Design Memorandum No. 23-10

SUBJECT: Bridge Painting Pay Items and Descriptions

REVISES: Indiana Design Manual Section 17-5.11 and Figure 17-5L

Paint Limits to be Shown on Plans for Existing Beam End Encased in Concrete⁽¹⁾ "Paint(ing)" will be revised "Coat(ing)" effective December 1, 2023.

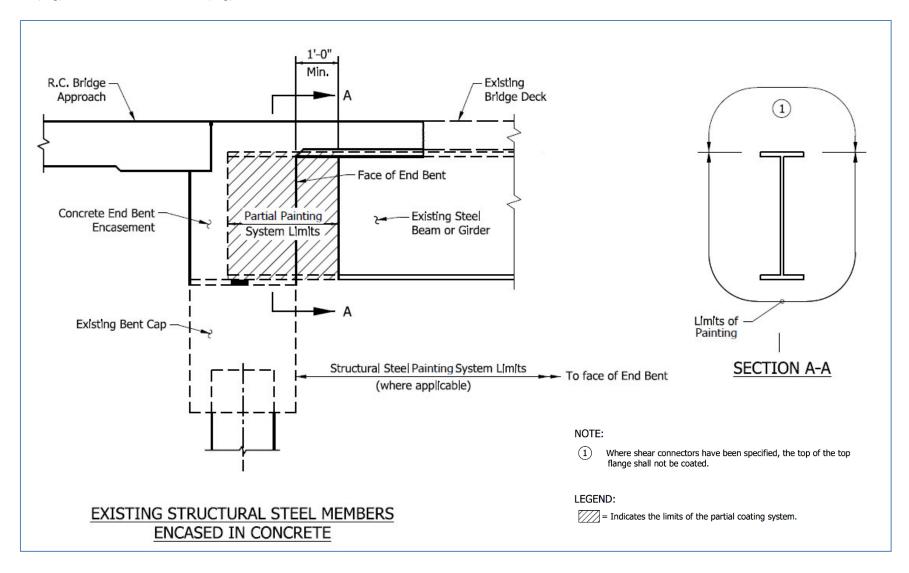
The limits of the partial paint system should extend 1 ft beyond the face of end bent. Designers must dimension the partial paint limits on the plans until a Standard Drawing is issued. If the project also includes complete bridge painting, the limits of this painting will be from face of end bent to face of end bent. Note that these limits will overlap a portion of the partial paint system limits. An illustration of the partial paint system limits to be shown on plans is included on page 4.
